LETTER AND CONCURRENCE FROM FLORIDA DEPARTMENT OF ENVIRONMENTAL
PROTECTION REGARDING DRAFT-FINAL RCRA FACILITY INVESTIGATION ADDENDUM
SOLID WASTE MANAGEMENT UNITS 44 AND 45 (SWMU44) (SWMU45) NS MAYPORT FL

8/15/2011

**RE: Draft-Final Resource Conservation and Recovery Act Facility Investigation
Addendum, SWMUs 44 and 45, Naval Station Mayport, USEPA ID #FL9 170
024 260, Mayport, Florida (Tetra Tech NUS, Inc., March 8, 2011)**

RESIDENTIAL SCTL SOIL BORING EXCEEDANCES SWMU 44 NAVAL STATION MAYPORT JACKSONVILLE, FLORIDA	
DRAWN BY S. STROZ CHECKED BY B. PEEBLES REVIEWED BY	DATE 10/27/10 DATE 11/15/10 DATE
CONTRACT NUMBER APPROVED BY APPROVED BY FIGURE NO.	DATE DATE Figure 3-1
SCALE AS NOTED

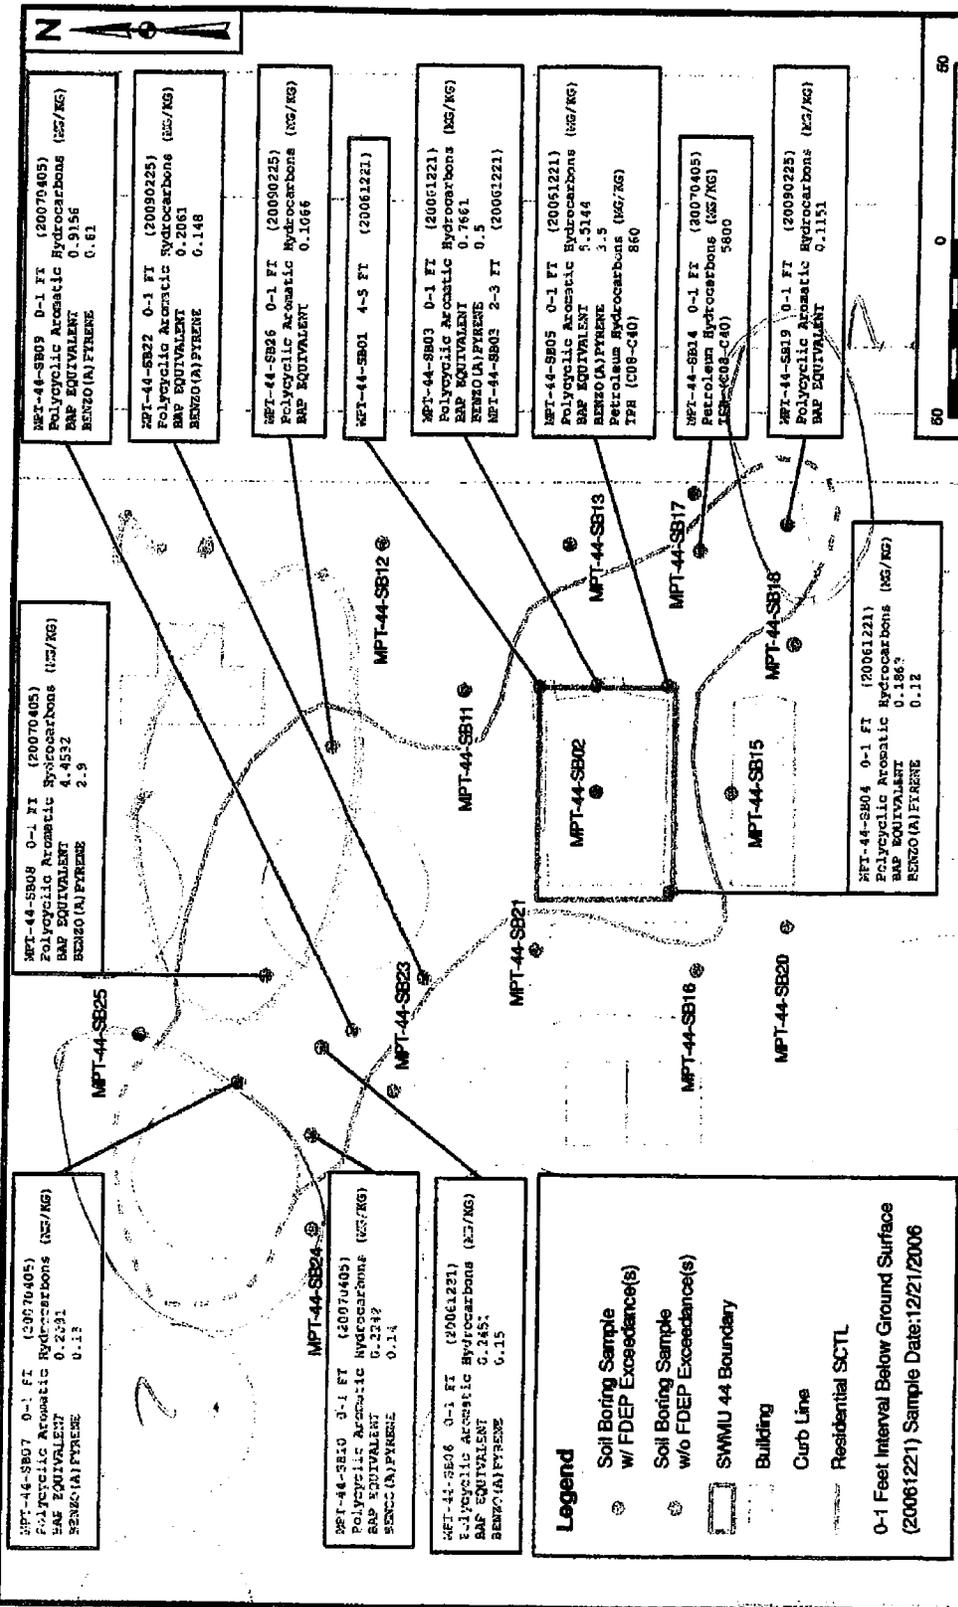
In the Conclusions and Recommendations section of this report it states *"The soil quality data associated with SWMUs 44 and 45 were compared against the Residential Direct Exposure SCTLs, and an area of inferred soil contamination was developed for SWMU 44 (see Figure 3-1) and SWMU 45 (see Figure 3-2). The concentrations of analytes within the areas are in excess of the Residential Direct Exposure SCTLs and are similar to the concentrations detected and reviewed in the RFI (see Appendix A, Table 4-4)." The report goes on to state "This suggests that vertical migration of TRPH and the six PAHs from the surface soils to the subsurface soils at SWMU 44 may not be occurring. The groundwater data further support the findings from*

While I'm not in agreement with the leachability argument presented in Tetra Tech's conclusions (TRPH and the six PAHs, and possibly others, are leaching through the subsurface and into the groundwater. They just aren't leaching in quantities above their cleanup target levels), I am in concurrence with the stated recommendation in this RFI Addendum, which is to proceed to a CMS to address the soil and groundwater contamination at these Solid Waste Management Units (SWMUs). However, after having evaluated Figure 3-1 (Residential SCTL Soil Boring Exceedances at SWMU 44) and Figure 3-2 (Residential SCTL Soil Boring Exceedances at SWMU 45) I believe there are several data gaps in the soil boring exceedances (please see attached figures). Additional soil analytical data is needed on the figures to be able to accurately draw the "Residential SCTL" line. Hopefully, this data has already been collected and just needs to be presented on the figures.
